Basis of this breakdown

1. Bulletin 3 (M-529 / M-530 / M-531, revision 4, 08/10/2026) was issued after the ductwork in the affected areas had been fabricated and installed per the Addendum 1 drawings. The change therefore includes **disconnecting and removing installed ductwork**, in addition to fabricating and installing the revised work.

Snowflake Fitout - 7 Times Square, Floors 29-31 | COP-SF-05 Bulletin 3 Revision

AFTER - Bulletin 3

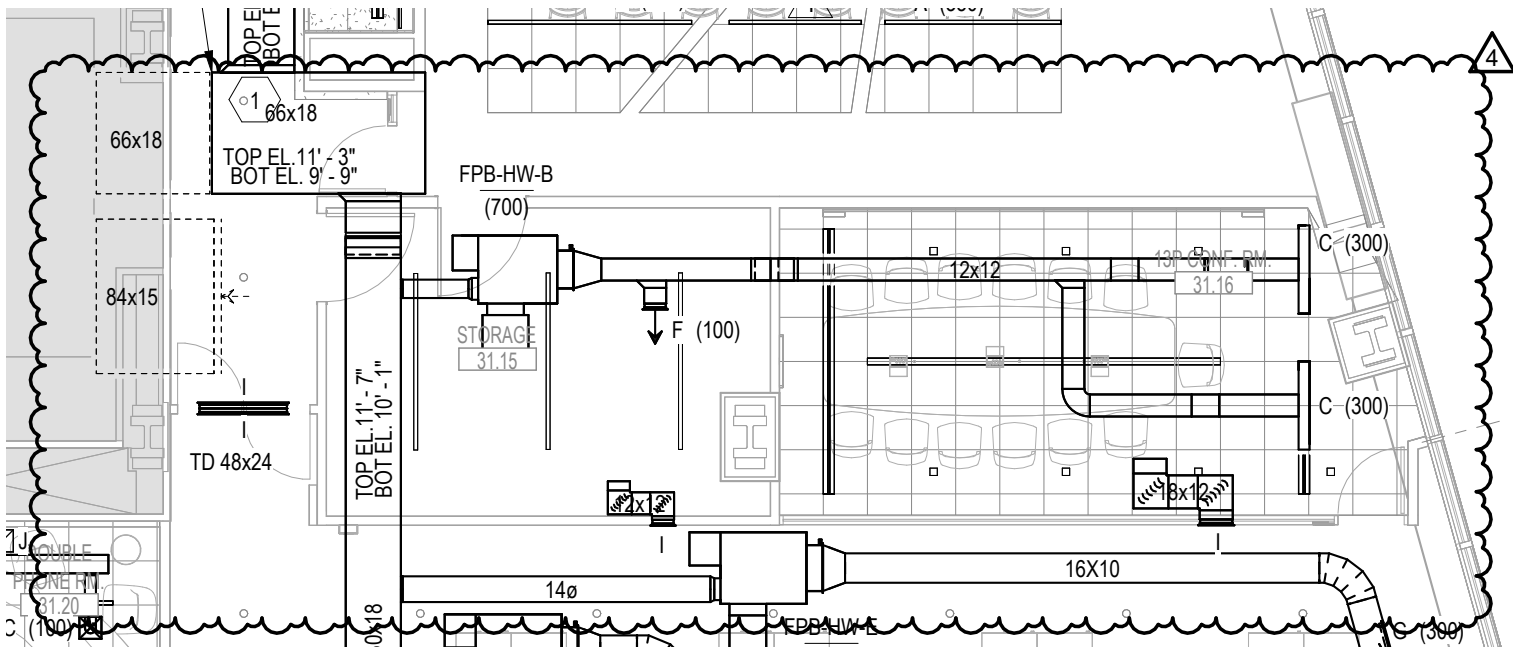
After (Bulletin 3): New TD 48x24; 12x12 and 18x12 grilles relocated.

Work required: Remove grilles and their duct connections; fabricate and install TD 48x24, relocate 12x12 and 18x12 grilles with duct connections at new locations.
